INNER WEST COUNCIL

DEVELOPMENT ASSESSMENT REPORT

Application No.	DA201700072
Address	26 Gibbens Street, Camperdown
Proposal	To demolish part of the premises and carry out ground, first and second floor alterations and additions to a dwelling house
Date of Lodgement	24 February 2017
Applicant	Tom Gilpin
Owner	Tom Gilpin and Verity Gilpin
Number of Submissions	1 submission
Value of works	\$593,500
Reason for determination at Planning Panel	The extent of departure from the FSR development standard exceeds staff delegation.
Main Issues	Floor Space Ratio
Recommendation	Approval subject to conditions

21 JUNE - 9AM

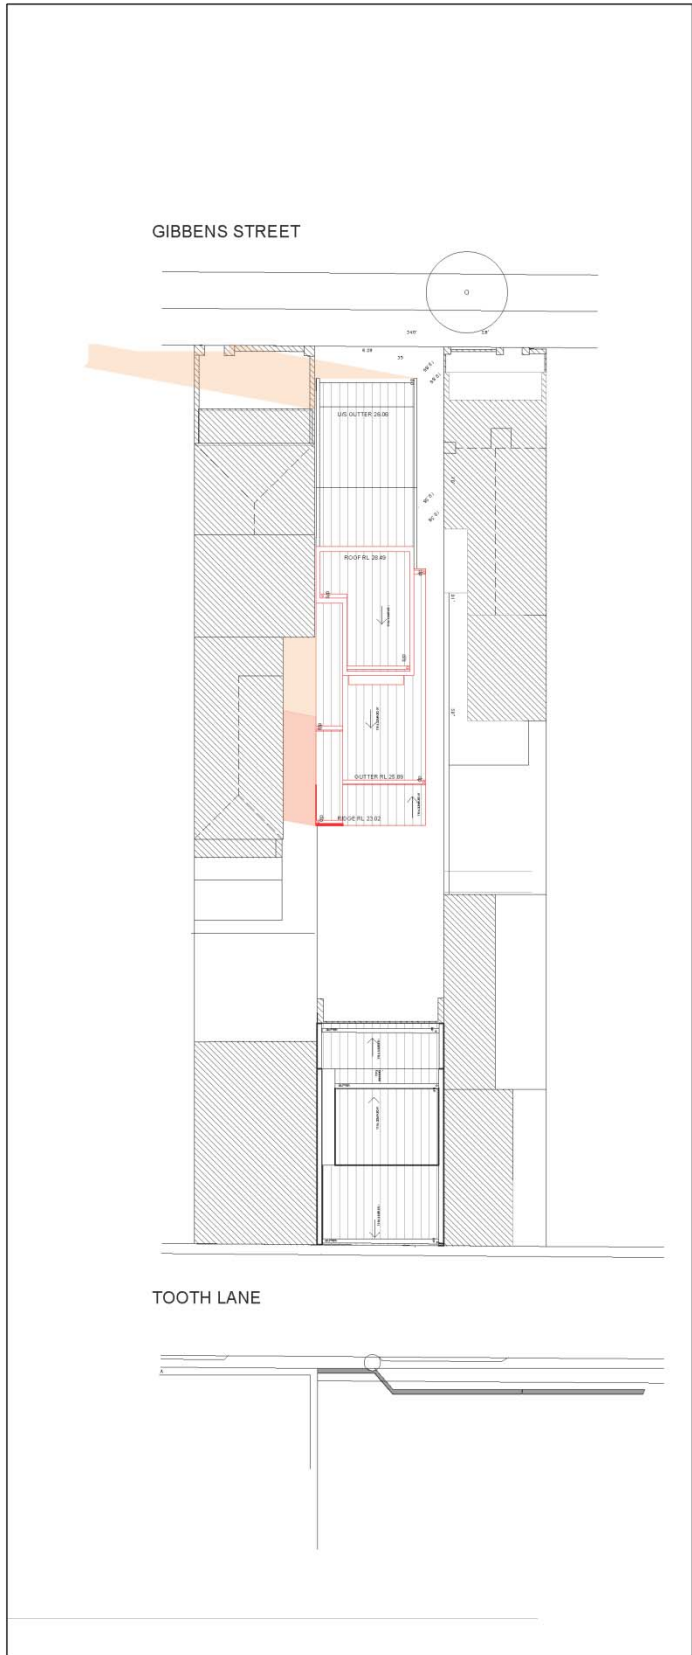
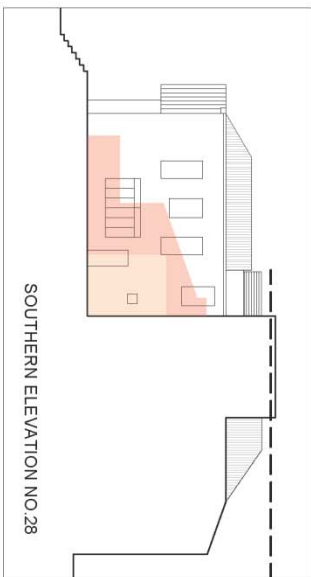
28 Gibbens Street contains 1 ground floor kitchen window and 3 bathroom windows and 1 stairwell window on the first floor level facing north (toward the subject property). The shadow diagrams indicate that these windows will continue to receive at least 2 hours of solar access between approximately 9:00am and 11:00am on 21 June, which satisfies Part 2.7 of MDCP 2011.

Figure 6 - North elevation also depicting building envelope of adjoining development at 28 Gibbens Street

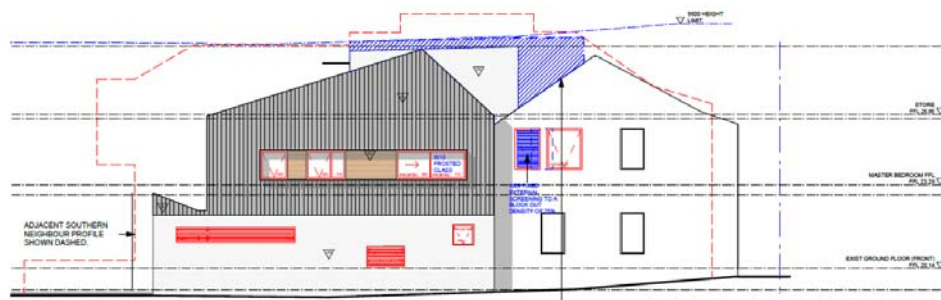
Built form within Gibbens Street and subsequent floor space ratio is considered to vary significantly. The adjoining site (28 Gibbens Street) did receive development approval in August 2013 for a similar scheme to that proposed, which required a clause 4.6 variation and endorsed an FSR of 1:1. We do not consider the standard to have been virtually abandoned or destroyed though the specific circumstance of the subject site and proposal is noted and on this basis, there is considered grounds for the departure.
